Backfeed v240

Changelog:

Figure 145-29a — Reflected voltage requirements

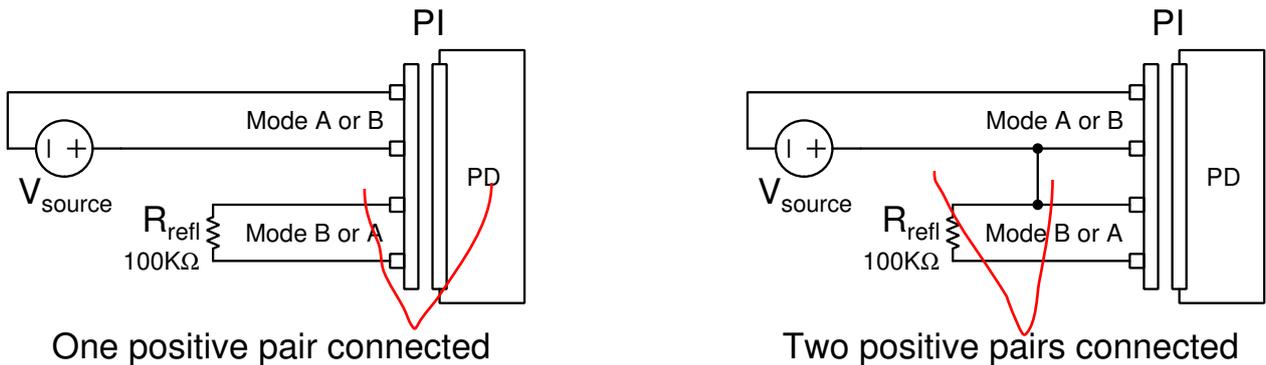
For a single-signature PD, when any voltage in the range of 0 V to $V_{Port_PD-2P\ max}$ is applied per any of the valid 2-pair configurations, defined in Table 145-20, that have only a single pair connected to positive V_{PSE} (see Figure 145-29a), the voltage on the Mode not connected to the voltage source, with a 100 k Ω resistor connected across that Mode, shall not exceed V_{refl} as defined in Table 145-29.

For a single-signature PD, when any voltage in the range of 0 V to 10.1 V is applied per any of the valid 2-pair configurations, defined in Table 145-20, including those with two pairs connected to positive V_{PSE} (see Figure 145-29a), the voltage on the Mode with at least one pair not connected to the voltage source, with a 100 k Ω resistor connected across that Mode, shall not exceed V_{refl} as defined in Table 145-29. This requirement does not apply if a voltage greater than 10.1 V has been applied on either Mode until the voltage on both Modes has been less than V_{Reset} for at least T_{Reset} .

For a dual-signature PD, when any voltage in the range of 0 V to $V_{Port_PD-2P\ max}$ is applied per any of the valid 2-pair configurations, defined in Table 145-20, including those with two pairs connected to positive V_{PSE} (see Figure 145-29a), the voltage on the Mode with at least one pair not connected to the voltage source, with a 100 k Ω resistor connected across that Mode, shall not exceed V_{refl} as defined in Table 145-29.
